3.2 MASTER RESPONSES

3.2.2 MASTER RESPONSE 2 — VISUAL RESOURCE IMPACTS

San Quentin State Prison Condemned Inmate Complex Project FEIR
P 3T053.01 04/05

EXHIBIT 1

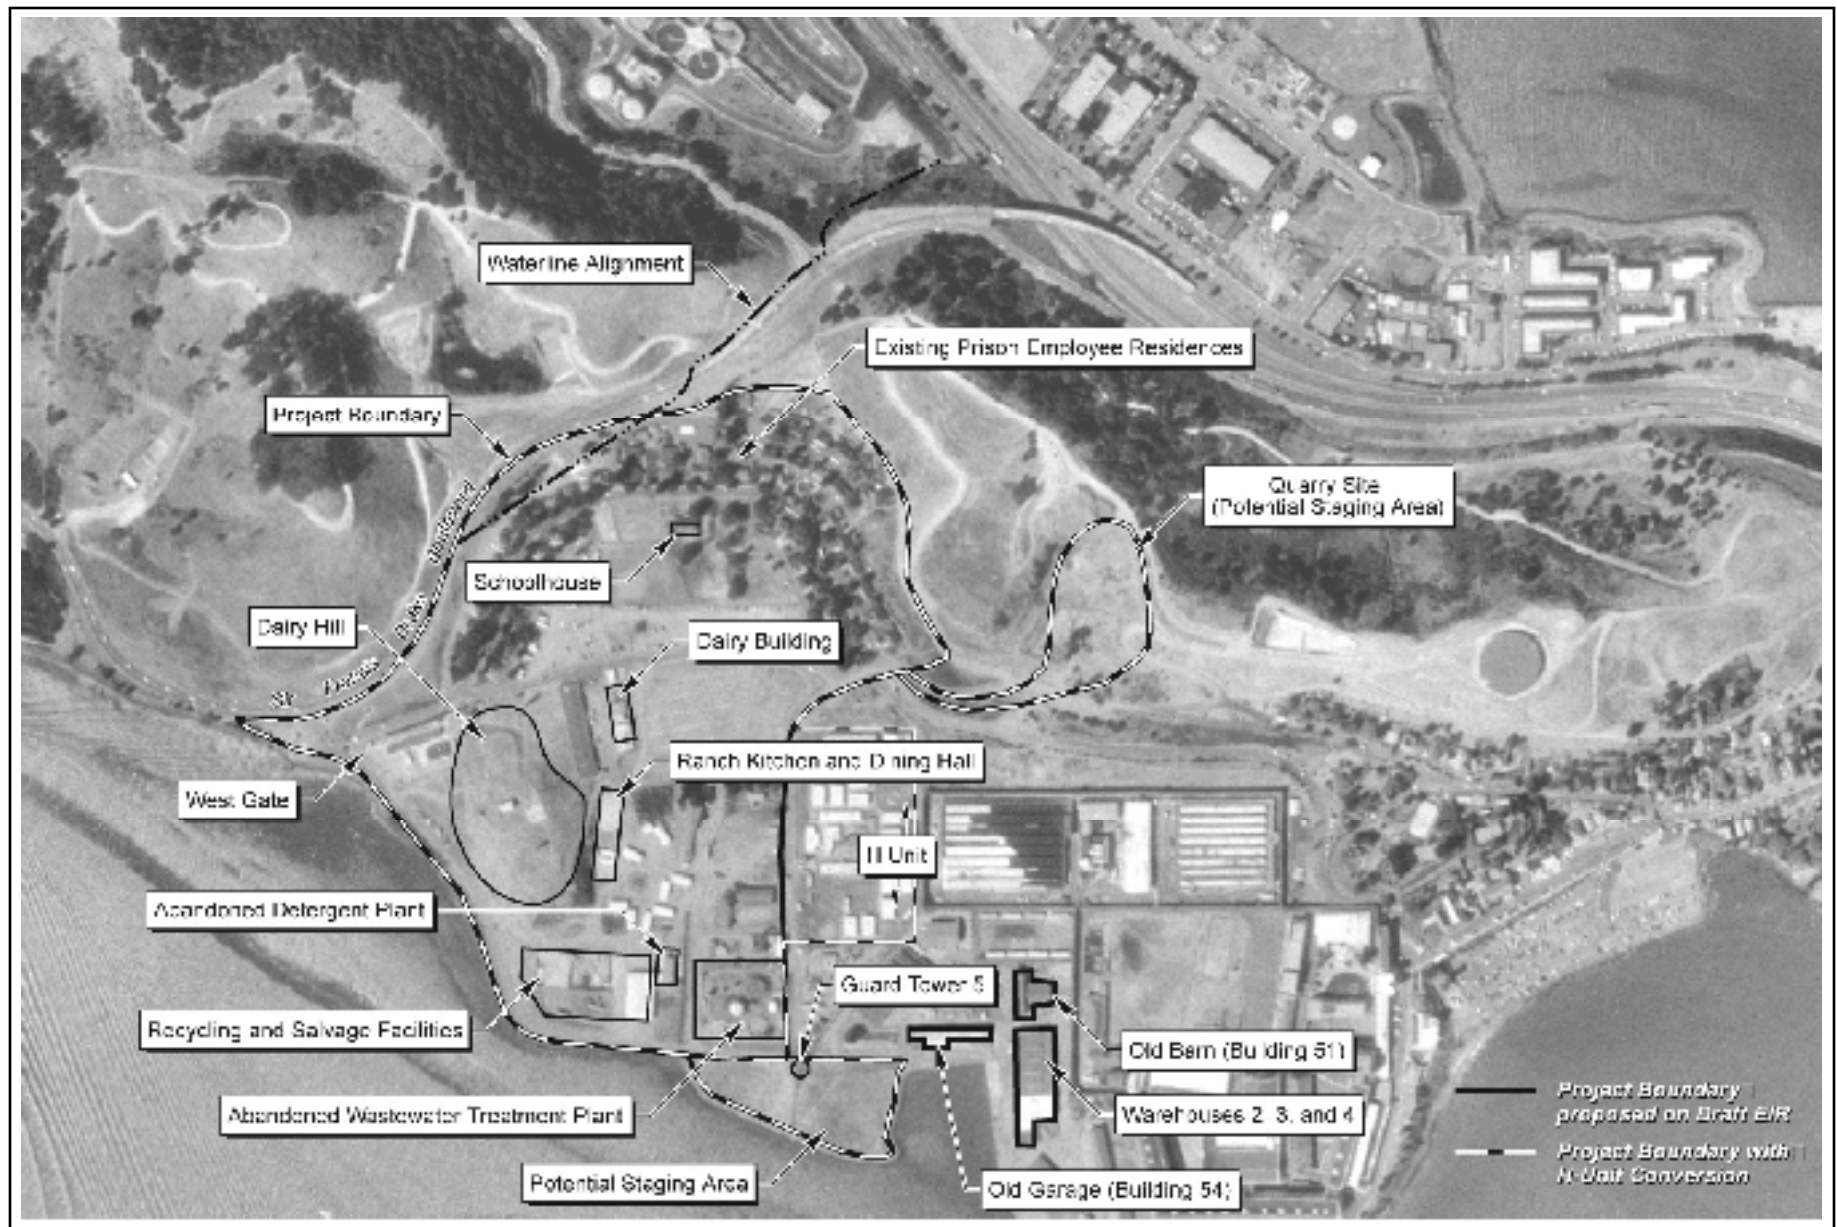
Several comments expressed concern that views of the project site from the Greenbrae Boardwalk community were not considered in the Draft EIR. The Greenbrae Boardwalk community is located east of the project site, just south of the Larkspur Ferry Terminal. Greenbrae Boardwalk is a community of pile-supported houses situated along a long boardwalk that extends from the shoreline of San Francisco Bay west toward SQSP. Representative photographs of the project site from the Greenbrae Boardwalk were taken on January 13, 2005. Photo A represents the existing views of the project site from the easternmost house along the Greenbrae Boardwalk. This viewpoint location would provide the closest, most unobstructed view of the project site.

Views of the project site from the Greenbrae Boardwalk community would be substantially similar in scale to views of the project site from the Larkspur Ferry Terminal presented in Exhibits 4.1-4a through 4.1-5c. The distance to the site from the ferry terminal and Greenbrae Boardwalk are similar, but the view angle is different. From Greenbrae the view would be more direct, mimicking the angle seen from the ferry boat (see Draft EIR photos in Exhibits 4.1-6a through 4.1-6c). In general, when looking from the Greenbrae Boardwalk (Photo A) the project site is located in the middle-ground to background view. Dairy Hill is visible in the center of the photograph; with the existing SQSP buildings are visible to the right of Dairy Hill. Greenbrae Boardwalk is south of the Larkspur Ferry Terminal and would afford views of more existing SQSP buildings because Dairy Hill does not provide a direct obstruction to existing SQSP buildings from this viewpoint.

The magnitude of the visual changes that would be anticipated from the Greenbrae Boardwalk viewpoint would be between the view changes described for the Larkspur Ferry Terminal viewpoint and the ferry boat viewpoint. As described in the Draft EIR (page 4.1-9), under the single-level design option, CDC would construct buildings that are smaller and have less mass than existing buildings on the site. Dairy Hill would be removed, which would expose more of the existing buildings (although from the Greenbrae viewpoint the project is likely to result in less exposure because more of the existing buildings are already visible from this viewpoint). Because the view of the CIC would be more direct and provide a broader view of SQSP from Greenbrae Boardwalk than from the terminal, the visual changes would be more prominent in the daytime. Similar to the ferry boat viewshed, the impact would be significant. Under the stacked design option, CDC would construct relatively tall buildings along the shoreline, which would add a new dominant feature to the overall viewshed, would block existing views of the architecturally distinct SQSP, and would not have the visual character of the old SQSP buildings. Therefore, the Draft EIR concluded that visual changes would be significant.

Although the specific viewshed from Greenbrae Boardwalk was not considered in the Draft EIR, sufficient information was included in the EIR to discern the similarities of this viewshed to others, and that the same significant impacts as described in the Draft EIR would occur.

Photo E: View looking east from elevated portion of U.S. 101.

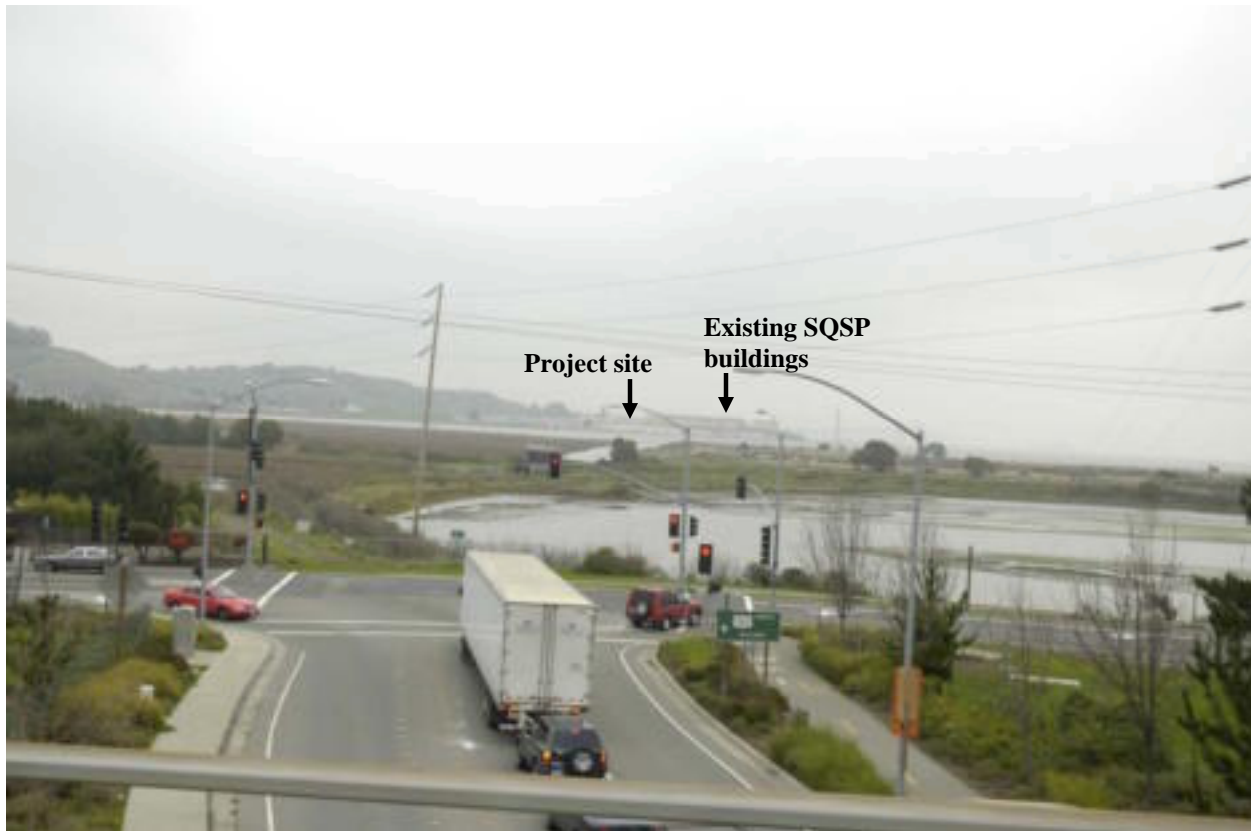
Several comments expressed concern that the Draft EIR did not consider the project's visual changes from U.S. 101. U.S. 101 is located approximately ½ mile east of the project site and runs in a north–south direction. Elevated portions of U.S. 101 provide intermittent, short-term views of the project site. Representative photographs of the project site from U.S. 101 were taken on January 13, 2005. Photo E represents the existing views of the project site from an elevated portion of U.S. 101 east of the project site (see Exhibit 1).

Views of the project site from this location are similar to views from the Corte Madera Ecological Preserve presented in Exhibits 4.1-2a through 4.1-3c in the Draft EIR. In general, SQSP is located in the background and appears as a peninsular extension from the shoreline. Views of local roadways are visible in the foreground with views of the Corte Madera Ecological Preserve in the middleground. The project site does not dominate the visual landscape; the viewscape from this location is broad. Implementation of the project would not change the form, line, or focal point within this viewshed, and the project would not alter or obstruct views of existing ridgeline or shoreline areas. Furthermore, views from this location would be brief and intermittent because of the high speeds at which vehicles travel along U.S. 101 and the presence of vegetation along the highway that would block views of the site. For all those reasons, visual impacts would be less than significant.

EXHIBIT 3

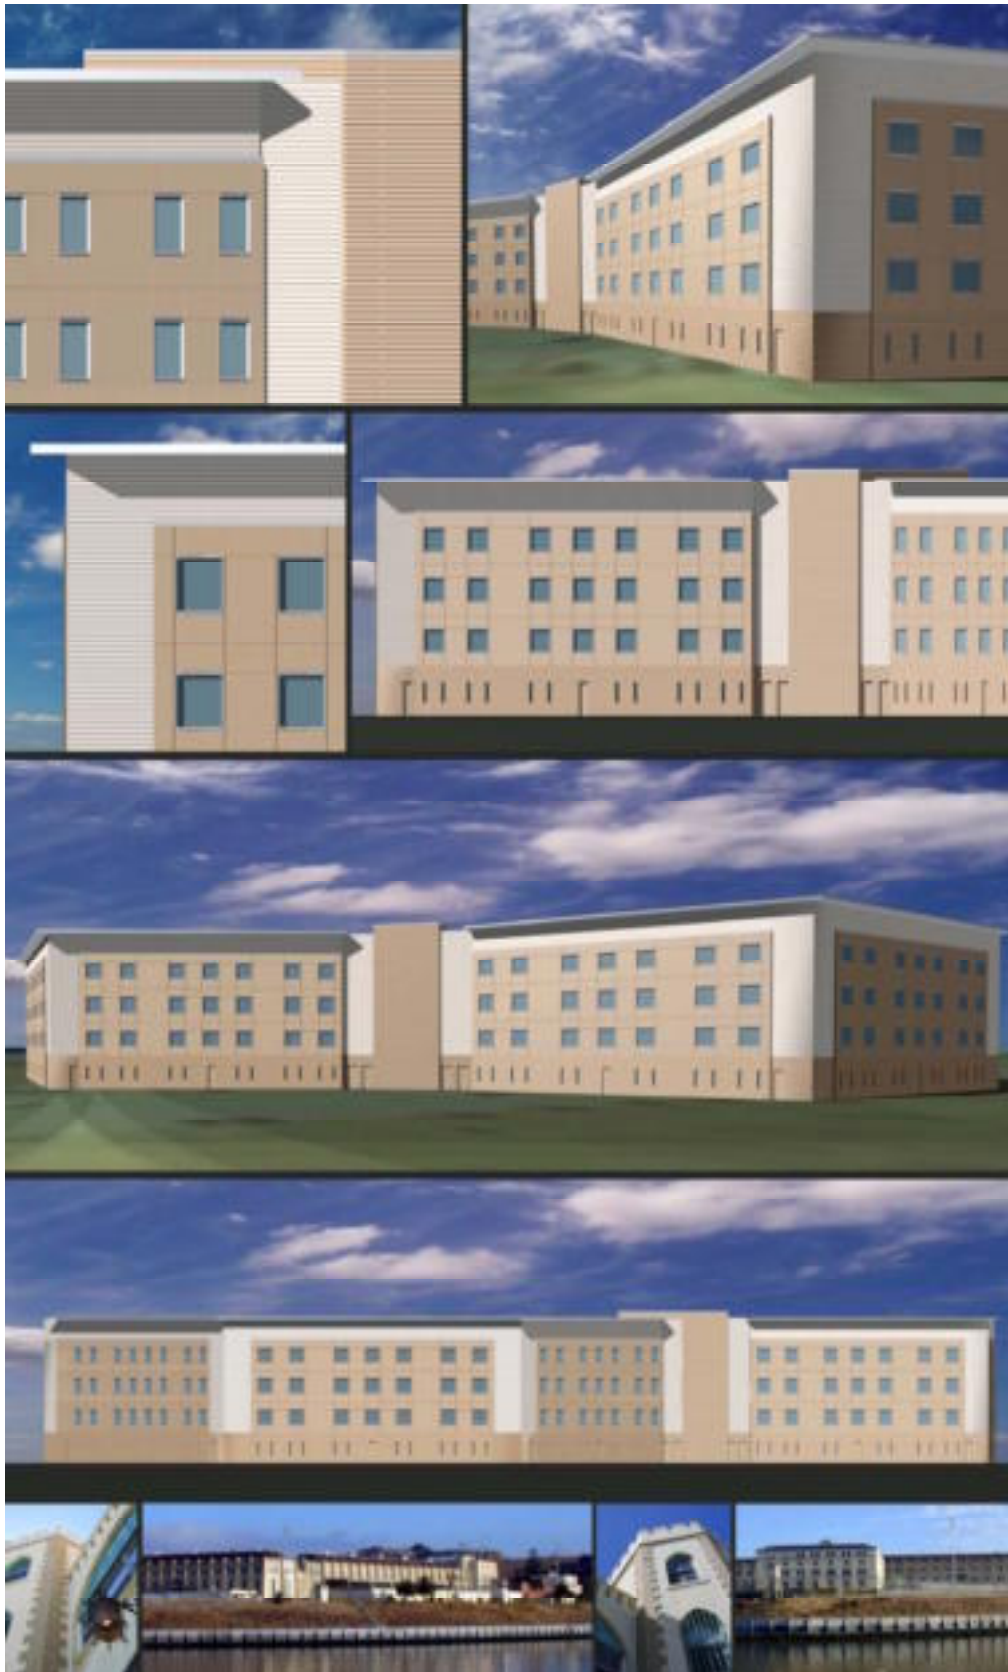
Several comments expressed concerns regarding the mitigation recommended for the project's visual impacts, specifically the lack of visual screening and the lack of architectural enhancements to reduce visual impacts. Following the close of the public comment period, CDC met with representatives of Greenbrae Boardwalk, the residential neighborhood with the most direct visual access to the site, to discuss their comments, concerns, and recommendations. In general, comments expressed concern with the large structures lacking architectural detail, lack of vegetation or screening at the project site, and nighttime lighting.

The design, siting, and architectural detail of correctional facilities are prescribed by CDC's established design protocols for such facilities. The design protocols provide, within cost limitations, necessary programming and space requirements for the inmates, while maintaining safety and security protocols for correctional officers, inmates, and the public. The size, construction materials, and minimization of architectural detail of modern-day correctional institutions are functions of requirements needed to provide a safe and secure facility, mitigate other impacts, and control construction cost. For example, the outer perimeters of correctional institutions are largely devoid of vegetation such that all ground areas are easily visible. Furthermore, an electrified security fence is proposed around the facility. Vegetation in proximity of electrified fences attracts wildlife, increasing the potential for accidental electrocution of animals coming in contact with the fence. Tier 1 mitigation required by USFWS (page 4.3-13 of the Draft EIR) requires removal of vegetation around electrified fences to reduce electrocution hazards, so ornamental landscaping is highly restricted. The design of prison buildings is intended to minimize escape potential, thus maximizing public safety. Buildings that provide architectural detail (i.e., cornices, pilasters, etc.) increase the potential number of hiding areas for inmates and decrease the security of the facility and the public.

The Draft EIR acknowledges that from some viewpoints, the proposed visual changes would be substantial and would result in a significant impact. Mitigation recommended in the Draft EIR would require CDC to minimize the visual prominence of the project buildings through use of paint and design elements, to the degree feasible, that reflect the character of the existing SQSP. As shown in Exhibit 3, CDC has proposed several design features to the project. These features have been proposed in response to BCDC comments and other public comments on the Draft EIR. In addition, CDC will continue to consult with the San Francisco Bay Conservation and Development Commission (BCDC) on project design and incorporate recommendations to the degree they are feasible. The term "feasible" is important here because CDC cannot commit to blanket changes to the design without thoroughly investigating security and cost issues, and thus the impact remains significant and unavoidable following mitigation.

The Draft EIR provided visual simulations (Exhibit 4.1-11 and 4.1-12) of two mitigation options that include use of paint and other design elements to enhance the visual appearance of the buildings while maintaining adequate security at the facility. Although screening measures, such as vegetation or other fencing or walls, are not a feasible option, CDC is continuing to refine the design options to ultimately improve site aesthetics. CDC is currently developing options for the exterior of the inmate housing units based on a variety of security, aesthetics, and operational considerations. Plans would include approximately 15% glazing in combination with approximately 85% metal cladding and/or stucco-type finish (Exhibit 2). Outside paint colors would vary and would compliment the surrounding environment. The final selection of building products and materials would consider aesthetics, durability against the harsh marine environment, long-term maintenance, and costs. The size, quantity, and location of exterior windows would be determined based on the amount of natural light that enters into the inmate cells, security considerations, and thermal impacts to the building's heating, ventilation, and air conditioning systems. Exhibit 2 presents a rendering of the design of CDC's standard housing unit. Exhibit 3 depicts additional design elements that CDC is considering for the project. CDC is determining the cost of these enhancements and is evaluating their effect on site security.
